Albert Bridge House, Manchester

Stage 1 Road Safety Audit

Design Response Report

Curtins Ref: 085538-CUR-XX-XX-T-TP-00005

APPENDIX A: LOCATION PLAN

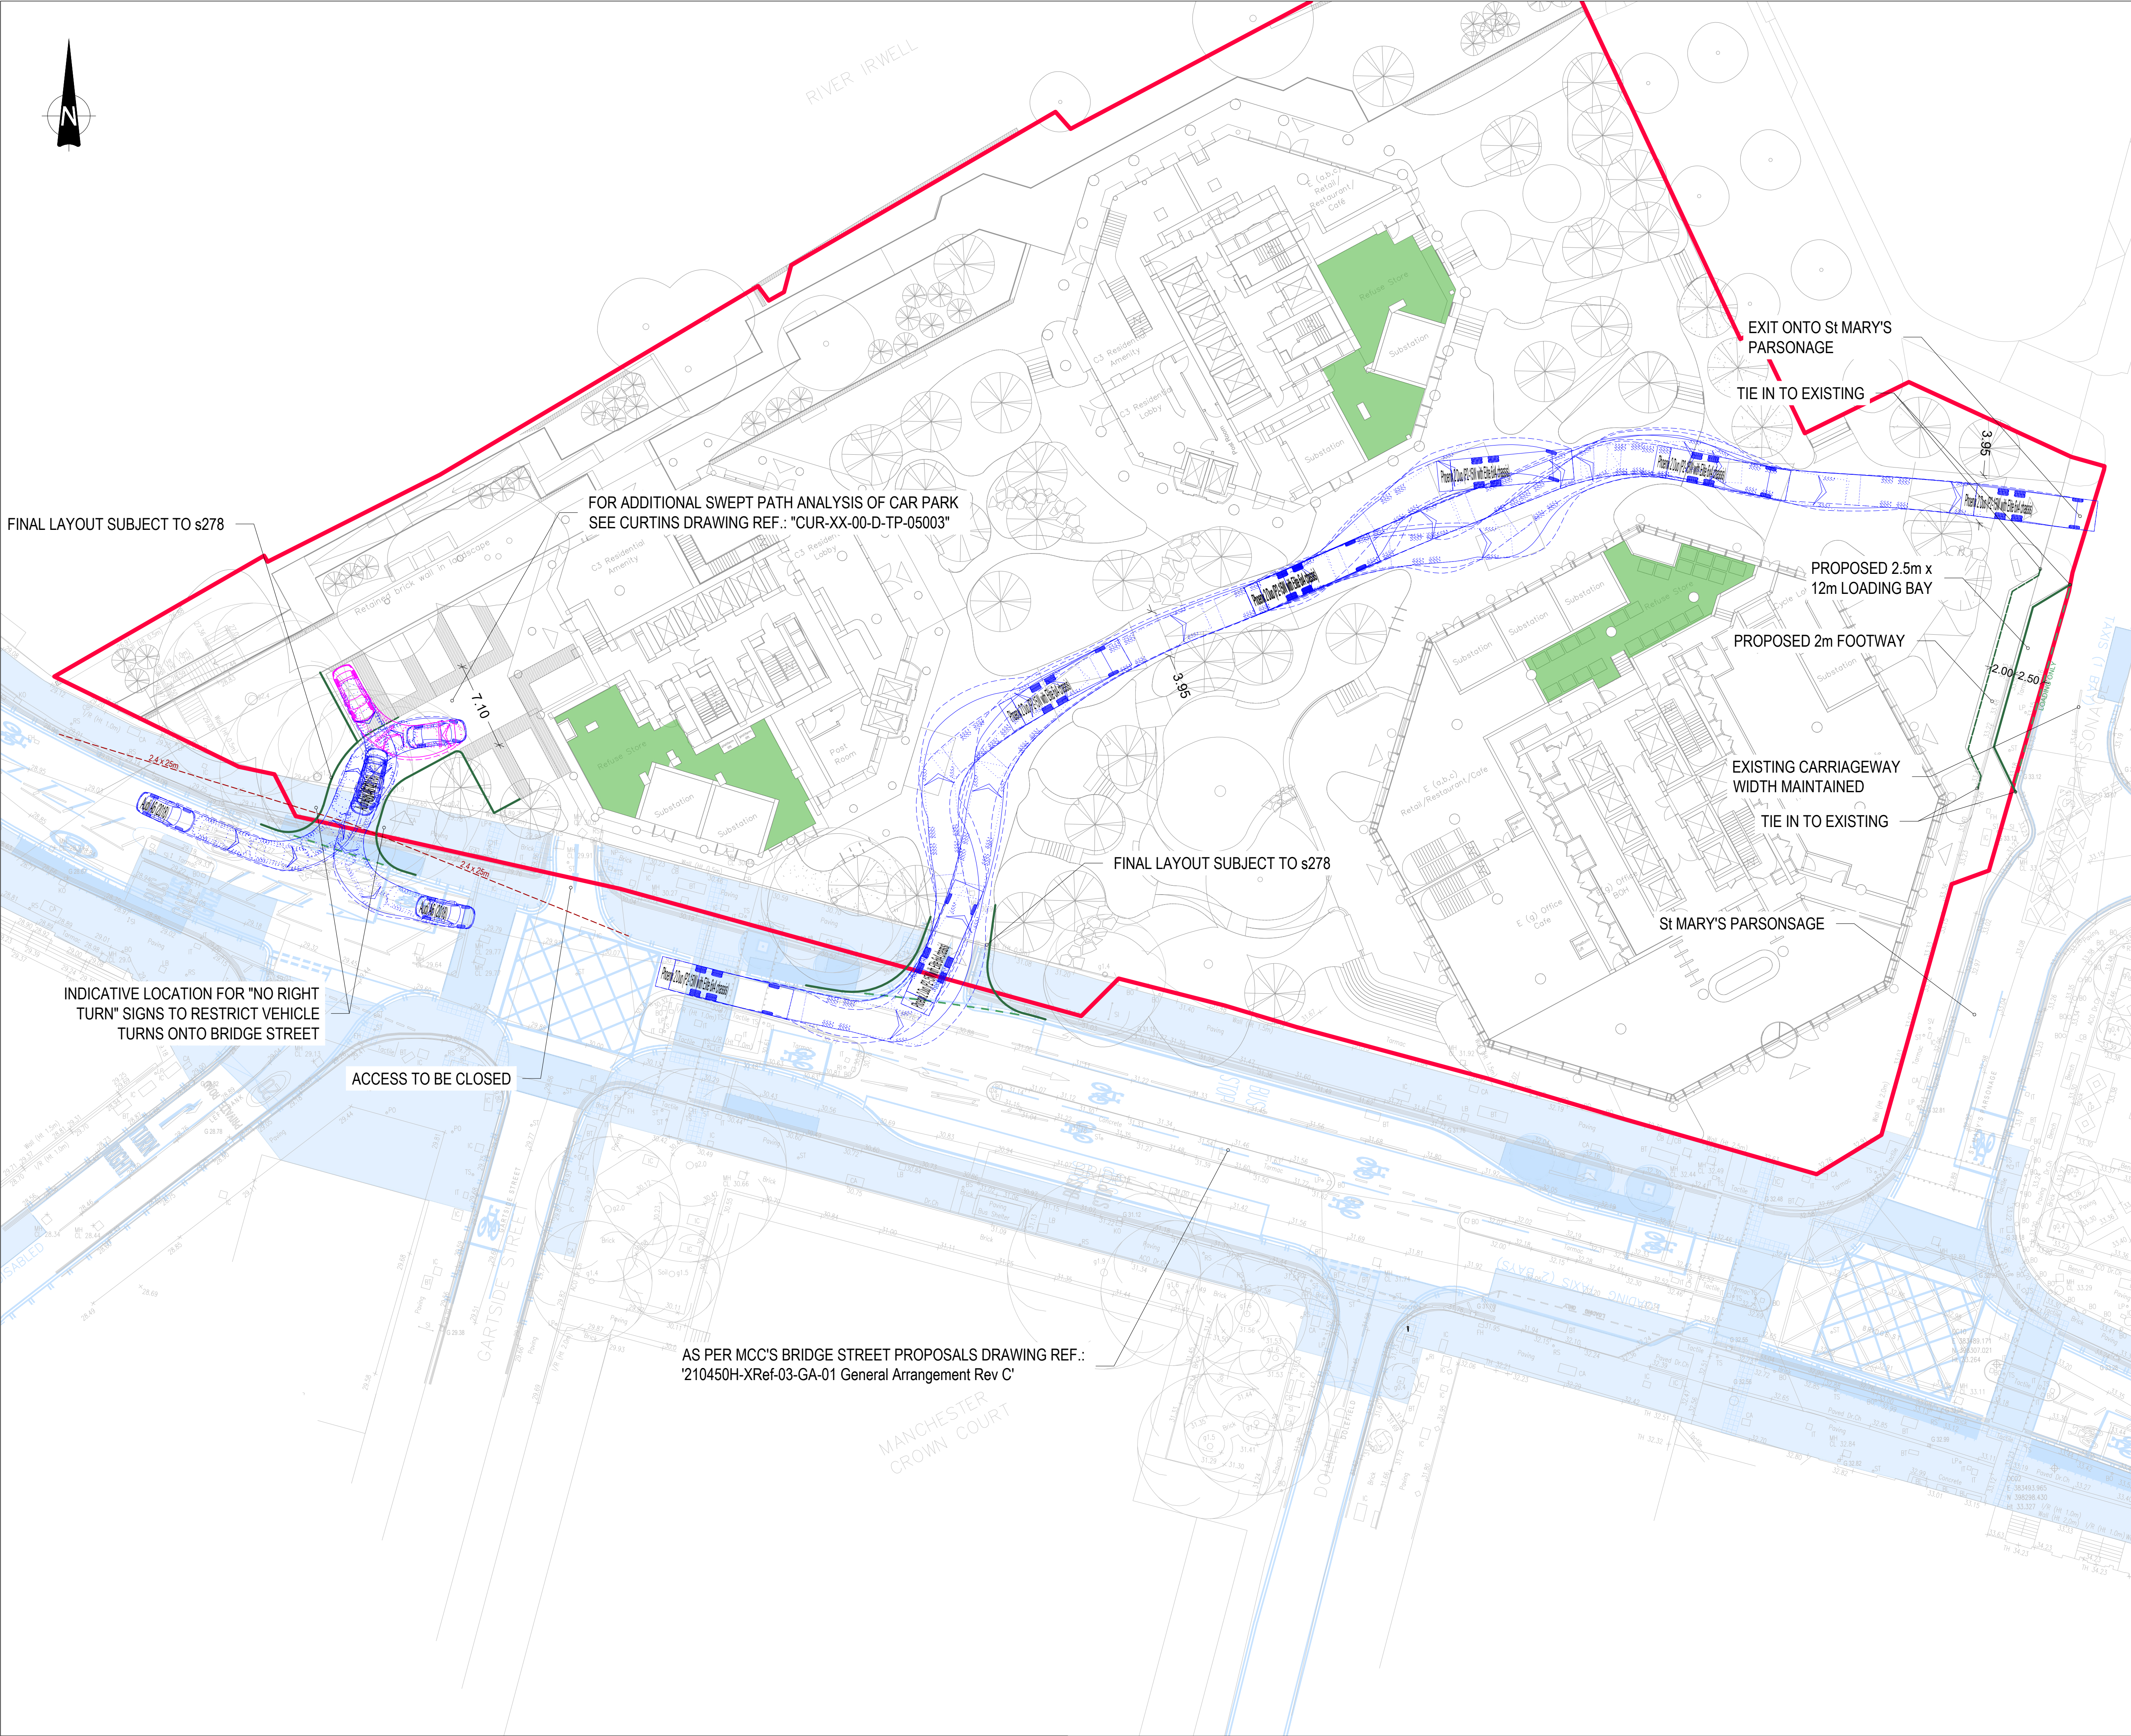
- 1.14 All problems identified in this Road Safety Audit Report are indicated on a location plan in Appendix A

4.1 PROBLEM

SUMMARY: Potential for restricted visibility to the right for traffic exiting the proposed development and potential for low-speed side impact crash types.

This access / egress will be newly constructed and located more towards a slight bend in Bridge Street. Although the alignment is good with a wide footway the auditor has no detail design proposal and note that there are existing large mature trees in the vicinity. The visibility afforded to drivers exiting the proposed development could be blocked by landscaping features resulting in side impact collisions between traffic on the main road and traffic emerging from the proposed development.

Ensure the visibility splay to the left and right are clear of obstructions by relocating the bus stop away from the visibility splays and restricting on-street parking.

4.2 PROBLEM

SUMMARY: Potential for low-speed conflict on Bridge Street.

There is a small refuge located in the vicinity of the planned access / egress and the audit team are concerned that this refuge may hinder drivers attempting to turn right out of the small car park which may result in unusual manoeuvres and conflict.

If right turn out of the car park is to be allowed, then the designer is to ensure there the refuge will not pose a problem for drivers turning efficiently and safely into Bridge Street.

4.3 PROBLEM

SUMMARY: Potential for vehicular -v- pedestrian conflict.

The audit team note that swept path analysis results have been presented however that analysis for the small car is limited and does not show if a driver can safely enter and exit the end parking bay of the 4 closest to building C3. The audit team are concerned that constraints within this area could result in drivers reversing out of the car park onto the pedestrian footway.

The auditor would like to see swept path analysis for all parking bays, particularly the one described above.

Item	Location	Summary	Recommendation	Design Team Response
Problem – 4.1	Relocated access / egress (small car park) Bridge Street opposite Leftbank	Potential for restricted visibility to the right for traffic exiting the proposed development and potential for low-speed side impact crash types. This access / egress will be newly constructed and located more towards a slight bend in Bridge Street. Although the alignment is good with a wide footway the auditor has no detail design proposal and note that there are existing large mature trees in the vicinity. The visibility afforded to drivers exiting the proposed development could be blocked by landscaping features resulting in side impact collisions between traffic on the main road and traffic emerging from the proposed development.	Ensure the visibility splay to the left and right are clear of obstructions by relocating the bus stop away from the visibility splays and restricting on-street parking	The recommendation is accepted. Drawing ref.: “86313-CUR-XX-00-D-TP-75001” has been updated to revision P05 to show visibility splays in both directions from the proposed car park access. The updated drawing is shown in Appendix B

Problem – 4.2	Relocated access / egress (small car park) Bridge Street opposite Leftbank	Potential for low-speed conflict on Bridge Street. There is a small refuge located in the vicinity of the planned access / egress and the audit team are concerned that this refuge may hinder drivers attempting to turn right out of the small car park which may result in unusual manoeuvres and conflict.	If right turn out of the car park is to be allowed, then the designer is to ensure there the refuge will not pose a problem for drivers turning efficiently and safely into Bridge Street.	The recommendation is accepted. Drawing ref.: “86313-CUR-XX-00-D-TP-75001” has been updated to revision P06 to add a leader at the car park entrance indicating “No right turns” signs, restricting vehicle turns onto Bridge Street. The updated drawing is shown in Appendix B
Problem – 4.3	Relocated access / egress (small car park) Bridge Street opposite Leftbank.	Potential for vehicular -v- pedestrian conflict. The audit team note that swept path analysis results have been presented however that analysis for the small car is limited and does not show if a driver can safely enter and exit the end parking bay of the 4 closest to building C3. The audit team are concerned that constraints within this area could result in drivers reversing out of the car park onto the pedestrian footway.	The auditor would like to see swept path analysis for all parking bays, particularly the one described above.	The recommendation is accepted. A new drawing ref.: “86313-CUR-XX-00-D-TP-05003” has been prepared to show additional swept path analysis for all parking bays in the proposed car park. The updated drawing is shown in Appendix C
